**Re: Third Submission Review – Murphy Creek PA 13, 14 And 9C - GDP Amendment, Site Plan with Adjustment and Plat**  
Application Number: **DA-1250-51**  
Case Numbers: **1995-2002-10; 2021-4019-00; 2021-3039-00**

# SITE PLAN with ADJUSTMENTS MURPHY CREEK PLANNING AREAS 9C, 13 & 14

DRAWING NO. SITE PLAN  
5 OF 39

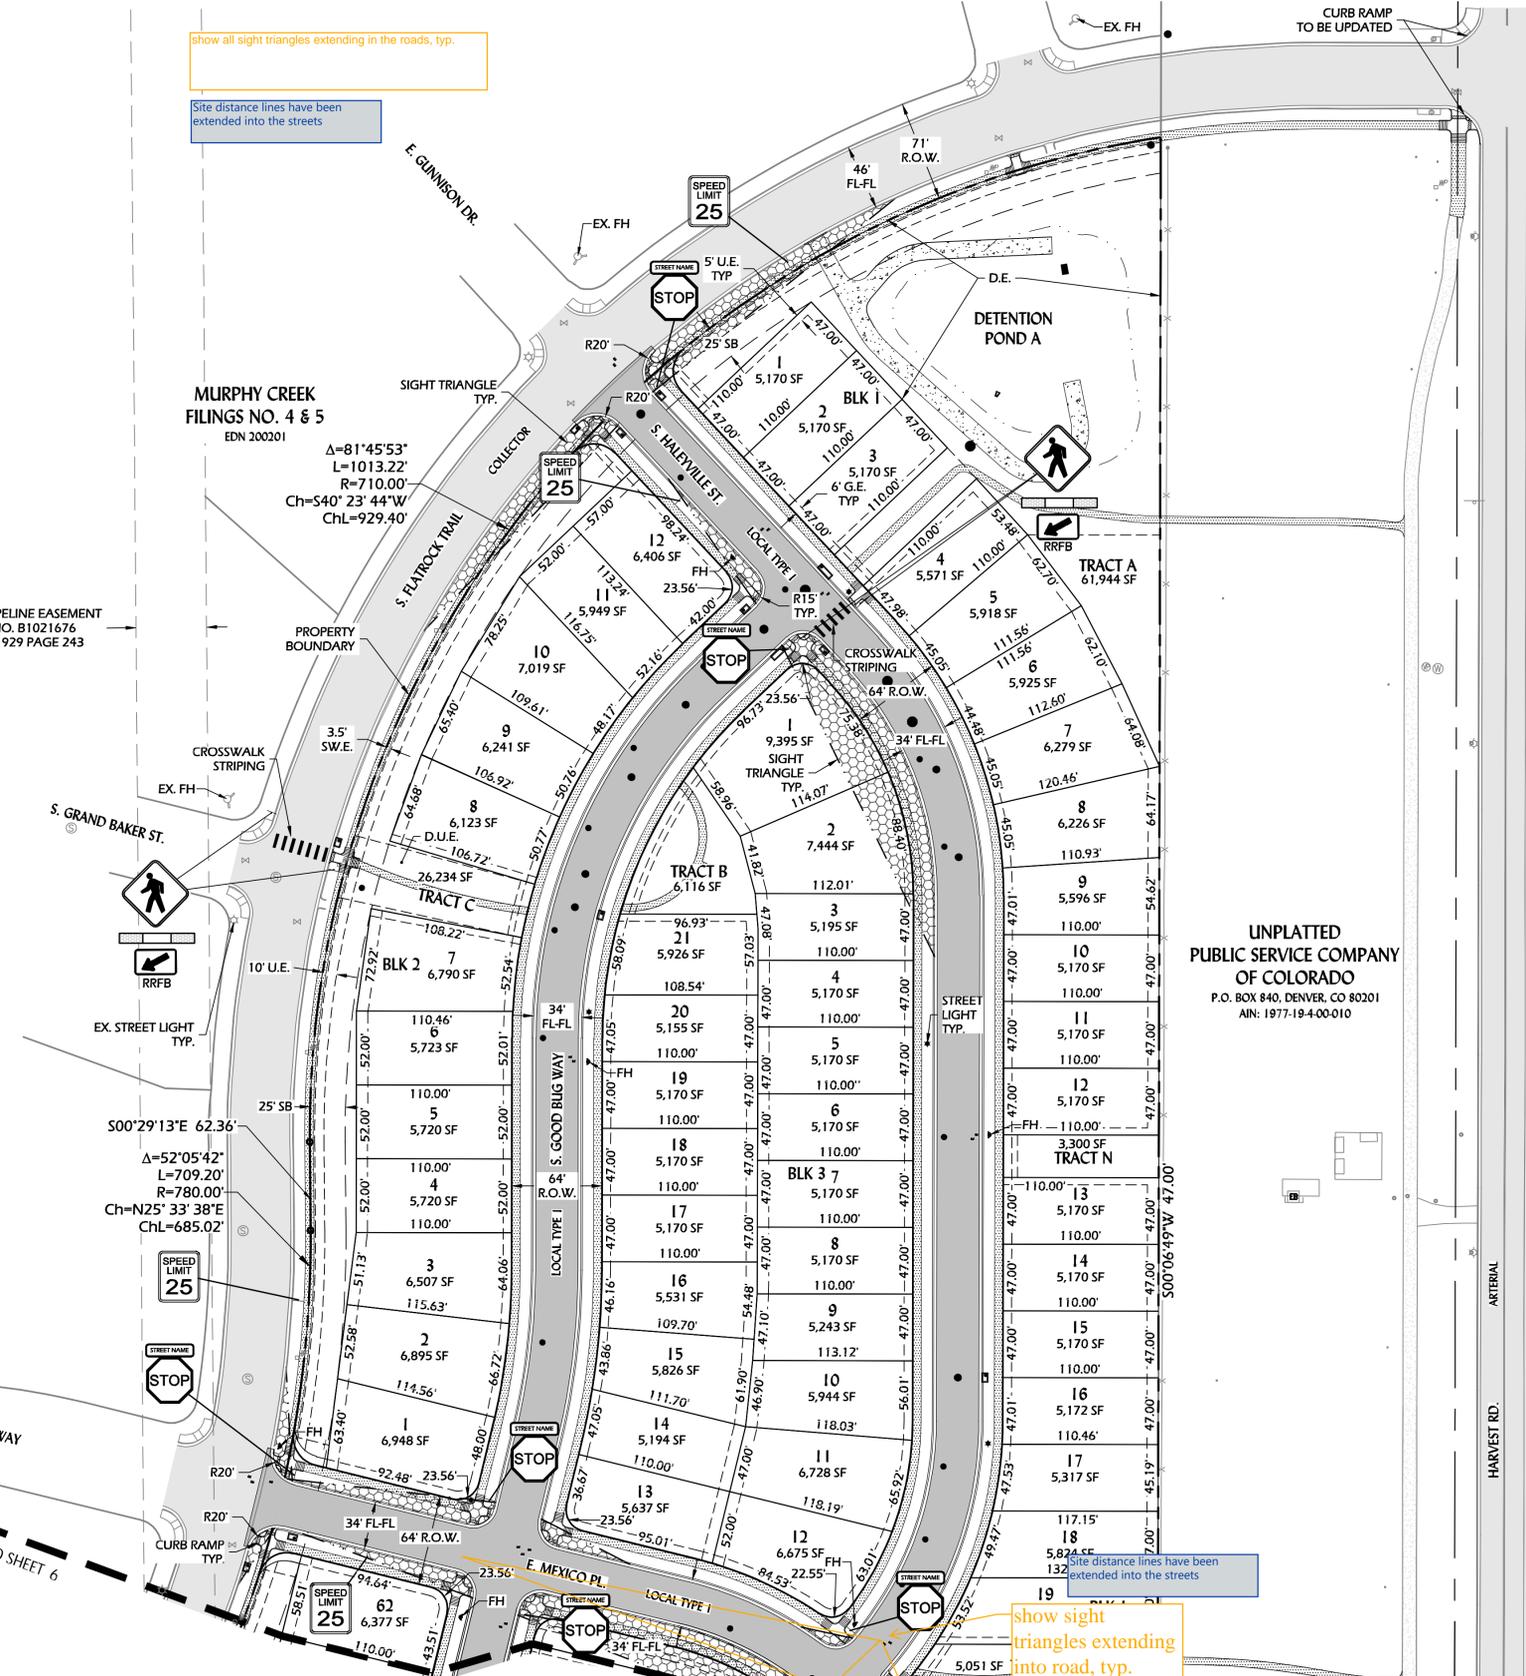
6B. Show all sight triangles extending in the roads, typ. – two instances.

show all sight triangles extending in the roads, typ.

show sight triangles extending into road, typ.

**Response: Sight distance lines have all been extended to show within the streets.**

Site distance lines have been extended into the streets
